ADDENDUM NO. TWO (2)
TOWN OF BRASELTON, GEORGIA
2026 GROUNDWATER EXPANSION AND DISTRIBUTION STORAGE
ISSUED JANUARY 23, 2026

RE: 2026 GROUNDWATER EXPANSION AND DISTRIBUTION STORAGE
EMI PROJECT No. 18-021

The purpose of this Addendum is to provide the omitted storage tank drawings, existing contours for treatment site, the pre-bid meeting attendance, and add Precon Corporation as a pre-approved concrete storage tank manufacturer. The following items of the Contract Documents are modified as part of this Addendum:

TYPICAL WALL SECTION

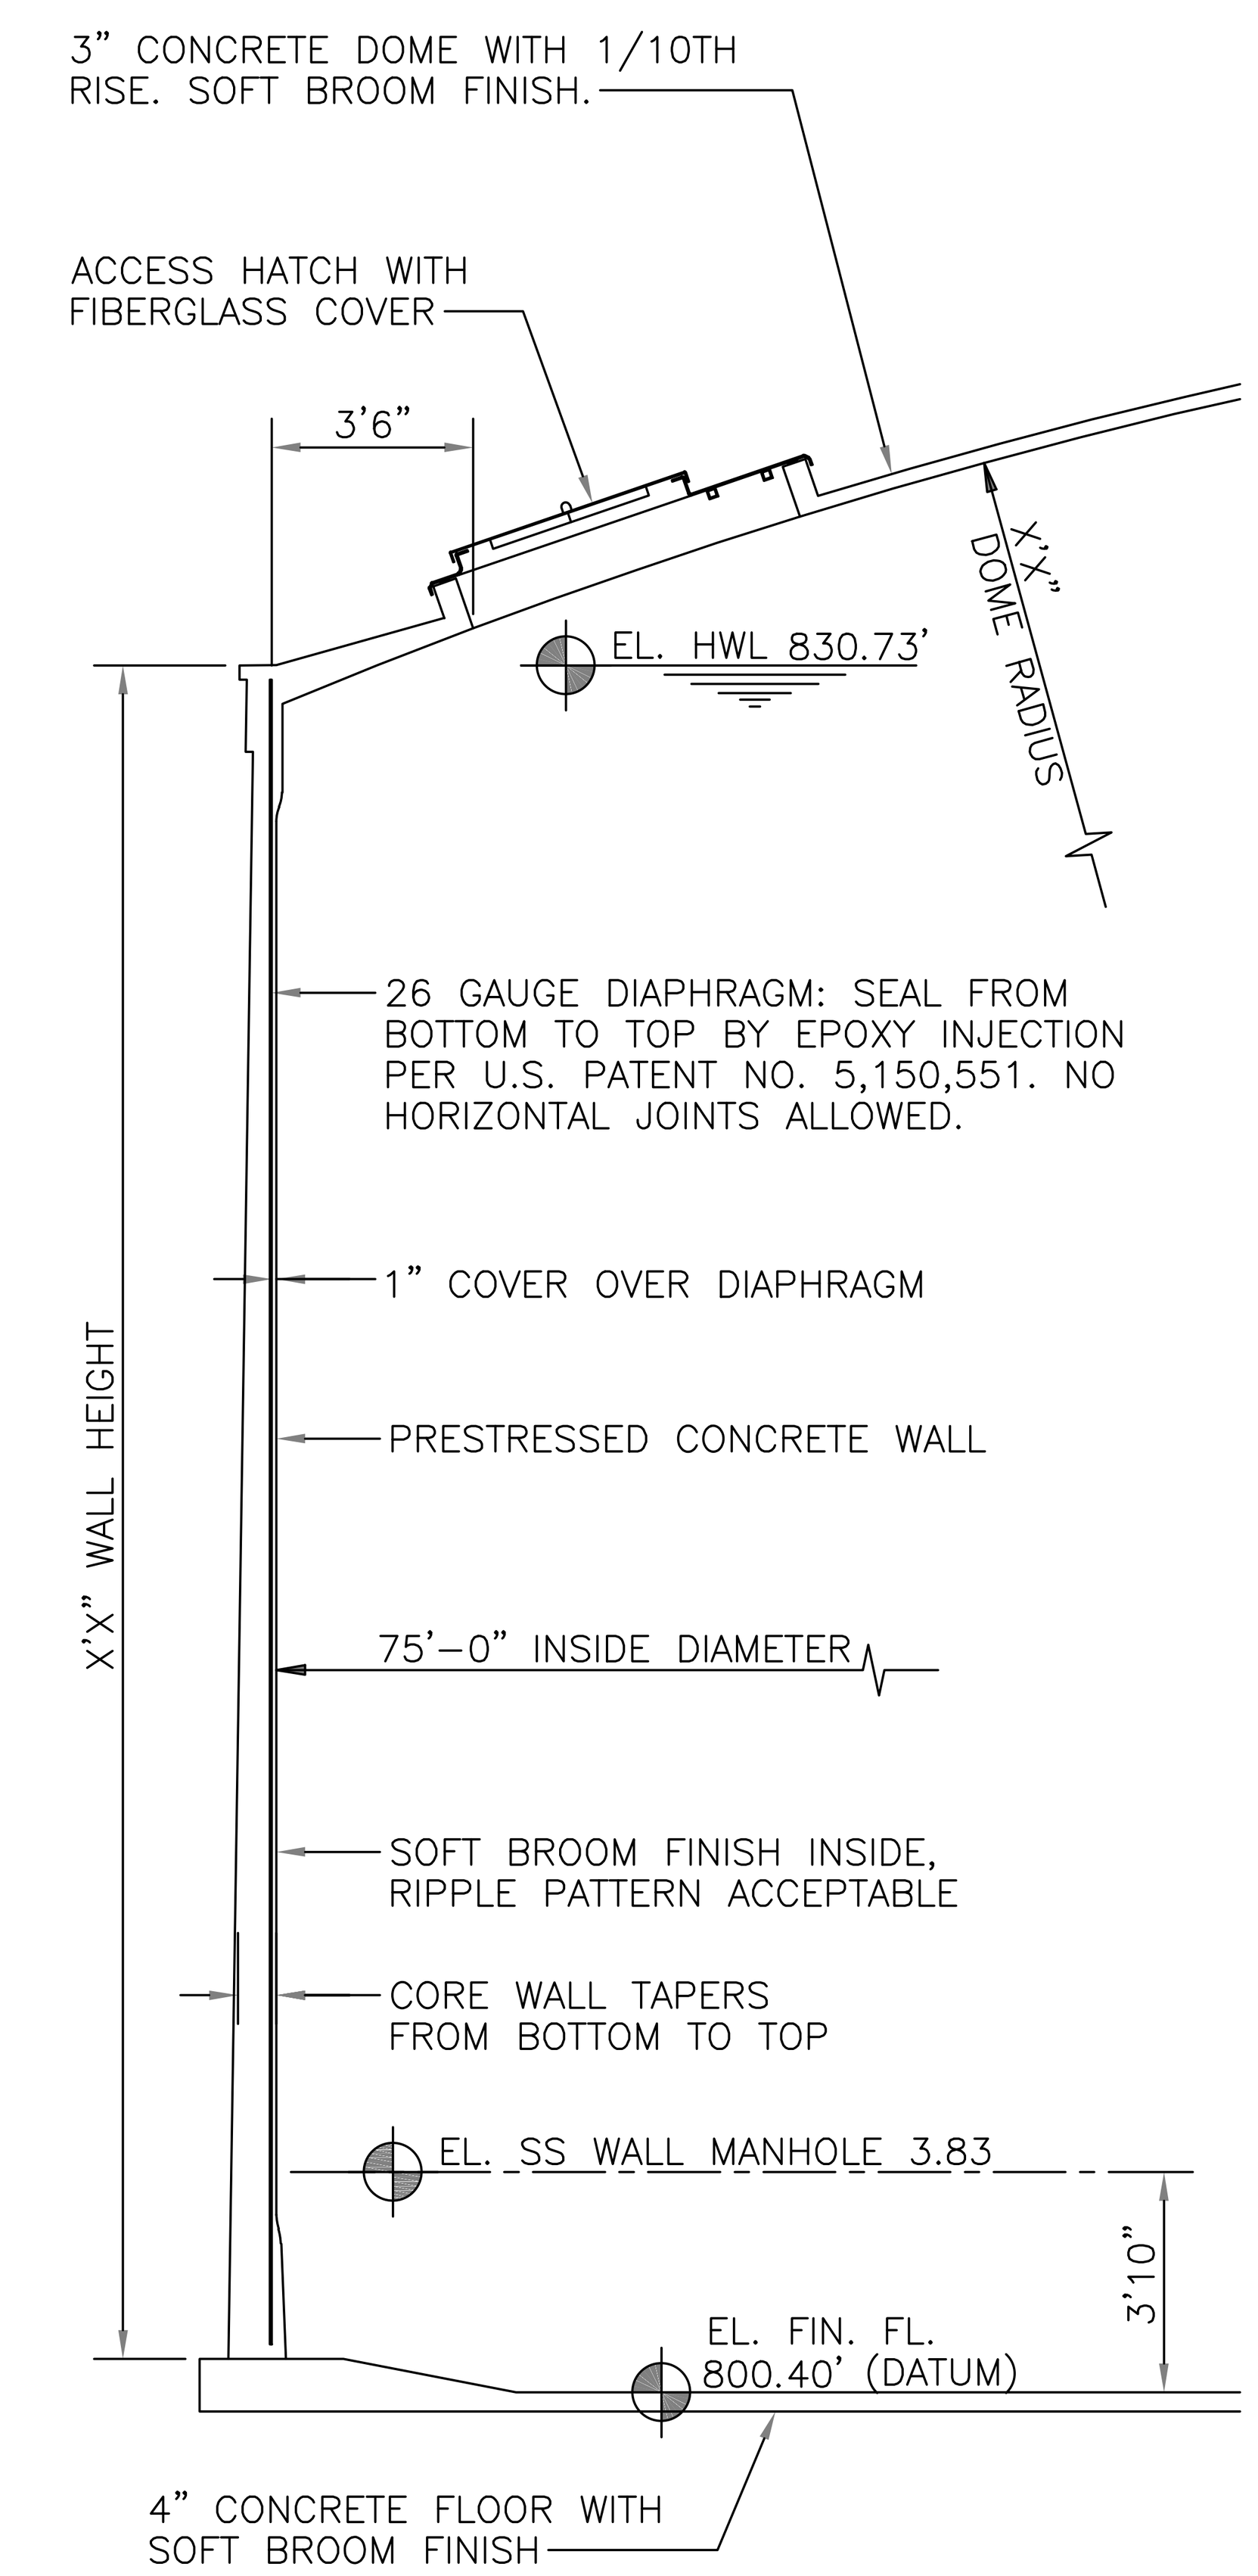
1. The contract documents appear to be missing plan sheets M7-M10 for the new tank listed in the sheet index. Can you please provide the missing drawings?

- <u>*Plan sheets M7-M10 have been provided to show plans for the concrete storage tank. See attached plan sheets.*</u>

EMI Response: Sheets M7-M10 were omitted in error. Please see the original sheets attached to this addendum.
